Product Change Notice (PCN)

PCN Number: **PCN-0455122R-01**

Product(s) Affected: **PJ-068B-SMT-TR**

PREVIOUS CUI DEVICES DETAIL / IMAGE NEW CUI DEVICES DETAIL / IMAGE

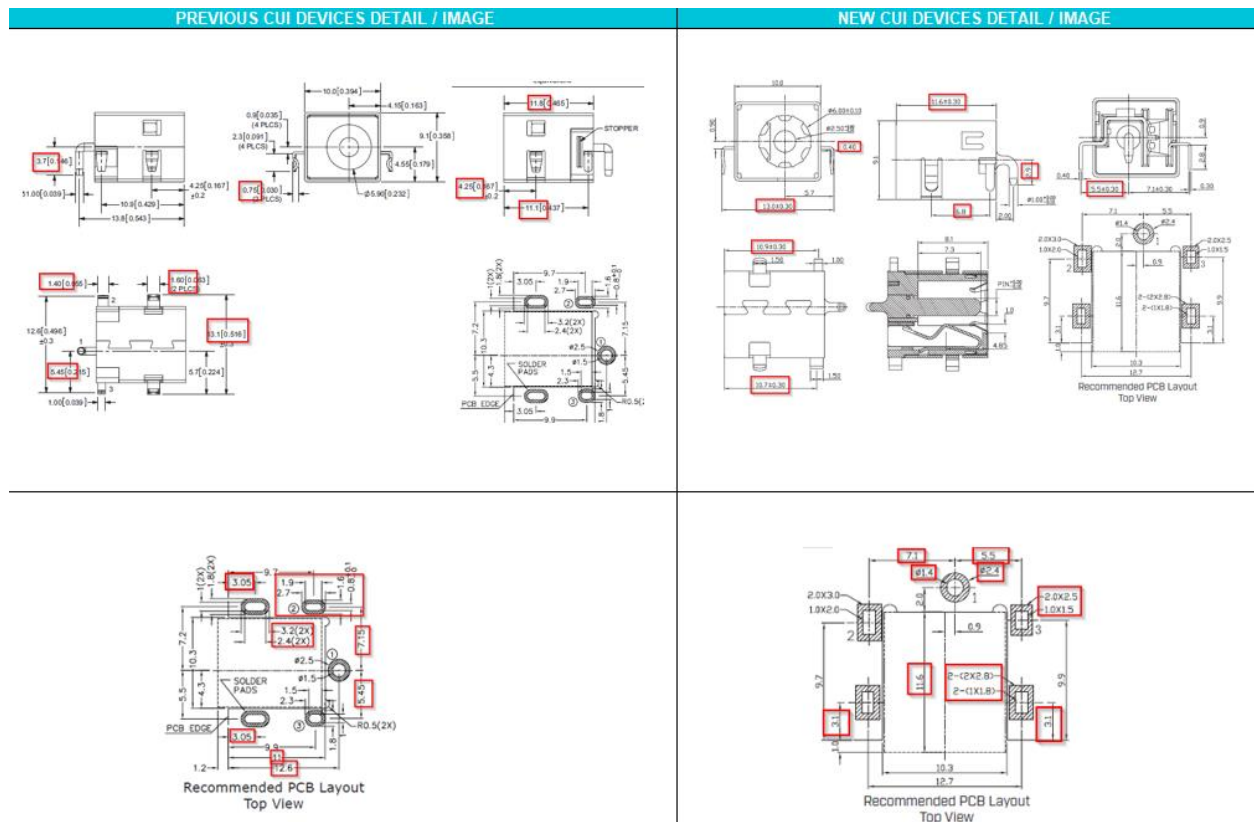
Description of Change: **Minor Housing and footprint differences. Material Change on the housing and terminals. See image Below**

MATERIAL	PLATING
center pin	brass	silver
terminal 1	brass	silver
terminal 2	copper alloy	silver
terminal 3	brass	silver
stopper	cold rolled steel	nickel
shield-A	brass	nickel
shield-B	stainless steel	
plastic	PA6T or equivalent

DESCRIPTION	MATERIAL	PLATING/COLOR
center pin	zinc alloy	nickel
terminal 1	zinc alloy	nickel
terminal 2	bronze t=0.30	silver
terminal 3	brass t=0.40	silver
shield-A	iron t=0.30	nickel
shield-B	SUS301 t=0.10	
housing	PABT (UL94V-D)	black
